Hi-Fi Products  
Service Bulletin

**Model:** DTC-57ES

**No. 296**

**Subject:** No FF or REW

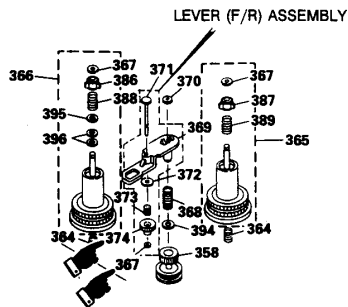
**Symptom:**  
(61)

FF and/or REW is inoperative due to washer (Ref. 367) and sustaining gear neck (Ref. 374) which come off.

Use the following lever assembly instead of individual lever, gear, etc:

DESCRIPTION	PART NUMBER
LEVER (F/R) ASSY	X-3364-581-1
